**Table of Contents for Block at 26<sup>th</sup> street**  
**Heritage Tree Variance Package**

**PROJECT NAME:** Block at 26<sup>th</sup> Street

**SITE PLAN:** SP-2011-0032C.SH

**SUBJECT:** Block at 26<sup>th</sup> Street  
SP-2011-0032C.SH

Exhibit #2

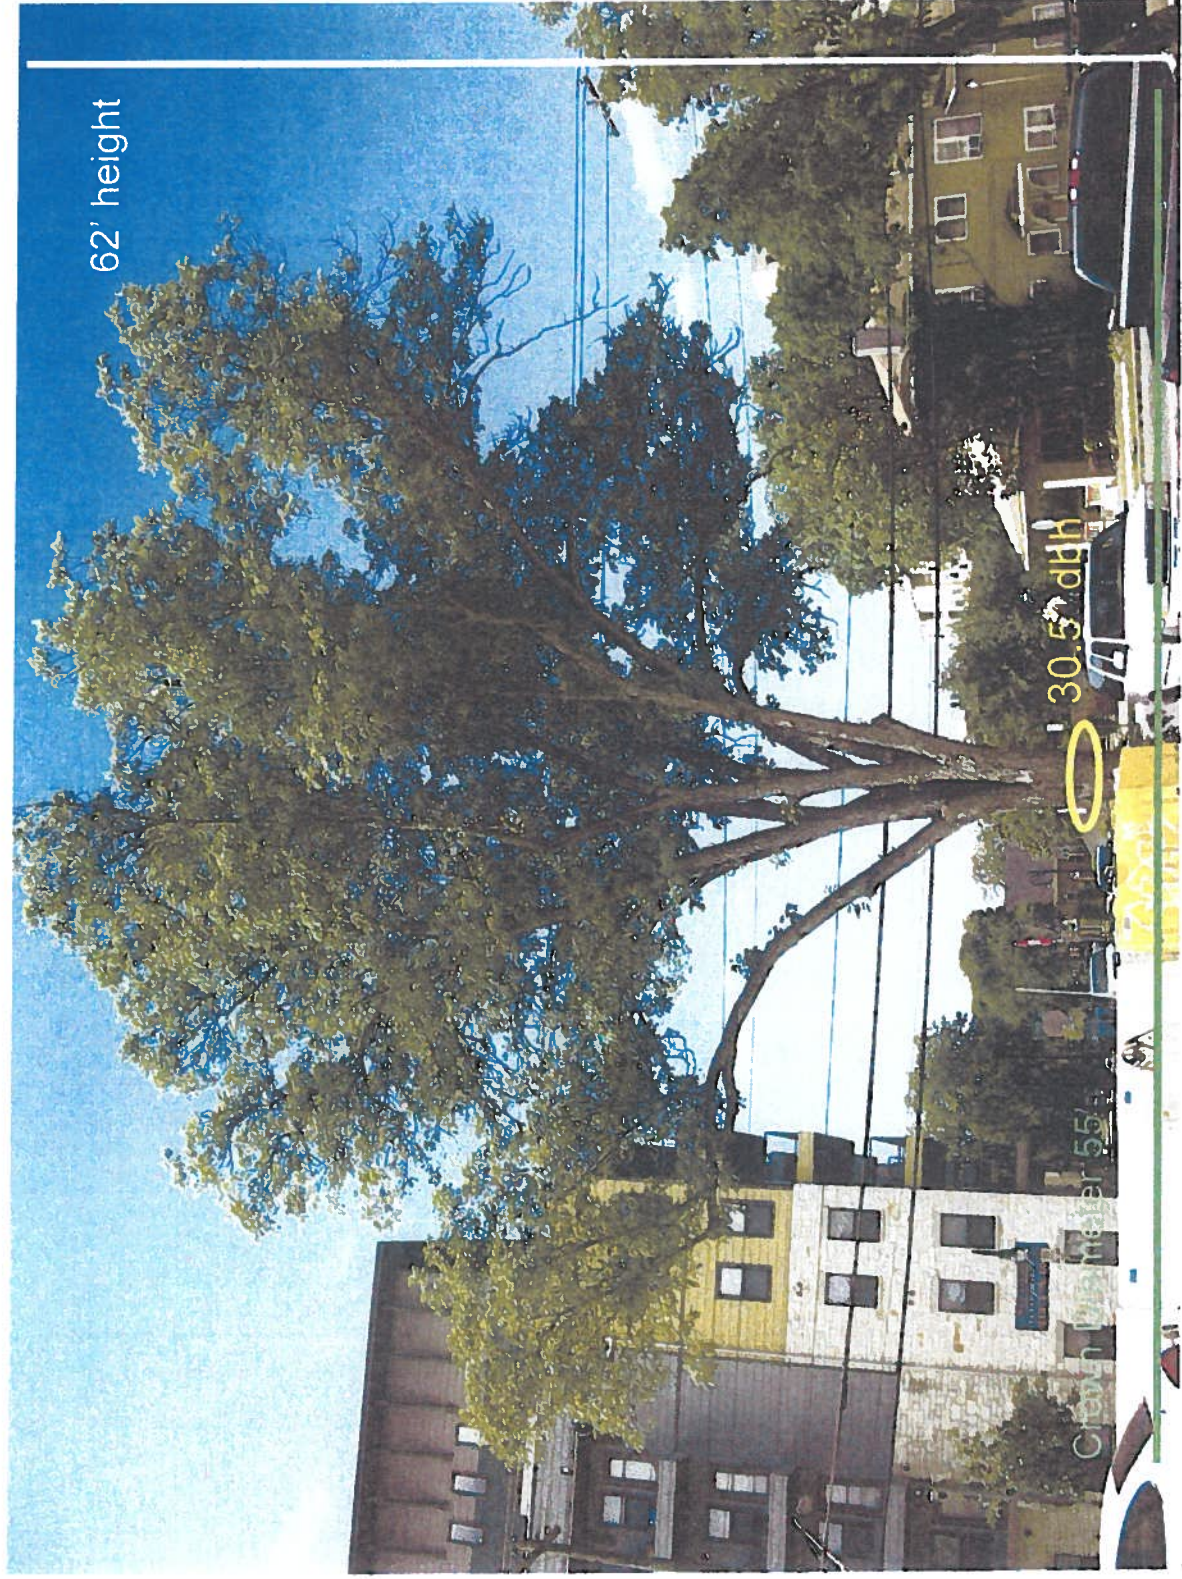
The subject tree is a 30.5 inch diameter at breast height (dbh) Pecan (*Carya illinoensis*). The tree height is 63 feet and the canopy spread is 55 feet (Exhibit 2). The trunk bifurcates into two co-dominate stems at eight feet above grade (Exhibit 3). Storm damage is evident by the presence of broken stems, though no noticeable decay or structural weaknesses are present (Exhibit 4). Minor pruning has occurred for utility clearing and likely from storm damage. There is minor deadwood and tip dieback in the crown though this is not uncommon in *Carya illinoensis* (Exhibit 5). This condition is likely exacerbated by poor soil and extensive compaction in the critical root zone (Exhibit 6). Given the aforementioned conditions, the subject tree is rated 'good' per the City Arborist tree evaluation (Exhibit 7).
